ADDENDUM NO. 1

for
**ALTERATIONS AND RENOVATIONS TO JOSEPH C. SHANER MEMORIAL
ELEMENTARY SCHOOL AND WILLIAM DAVIES MIDDLE SCHOOL**

Issued: March 5, 2019

FVHD PROJECT #4937B /NJDOE #1940-060-18-1000
Shaner Memorial Elementary School, 5801 Third St., Mays Landing, NJ 08330

Drawing Number
A104a

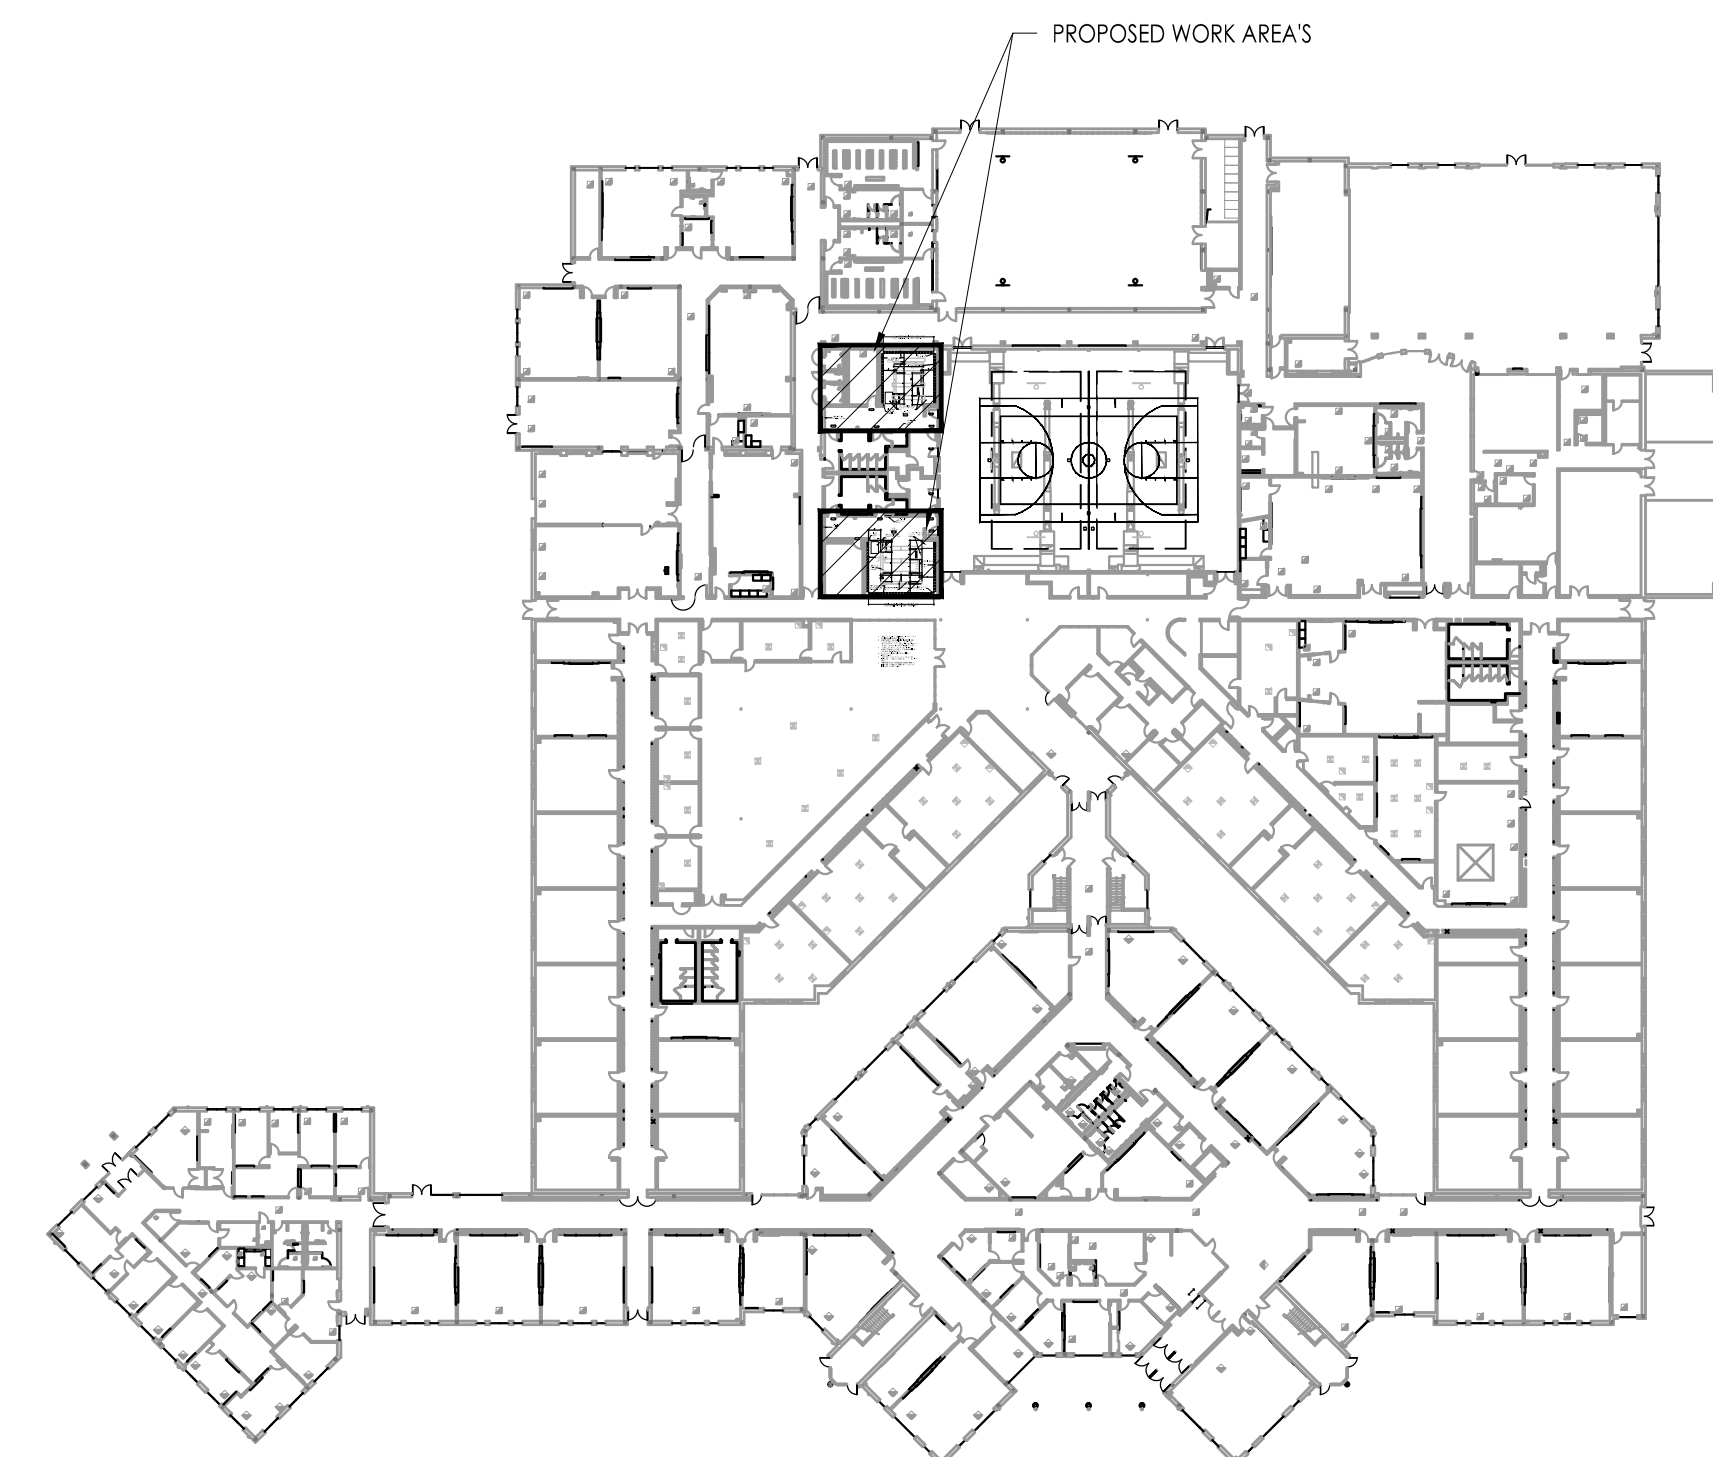
REFER TO A102a FOR CONTINUATION OF TILE LAYOUT.

Drawing Name
LOCKER ROOM ALTERATIONS
-ALTERNATE BID
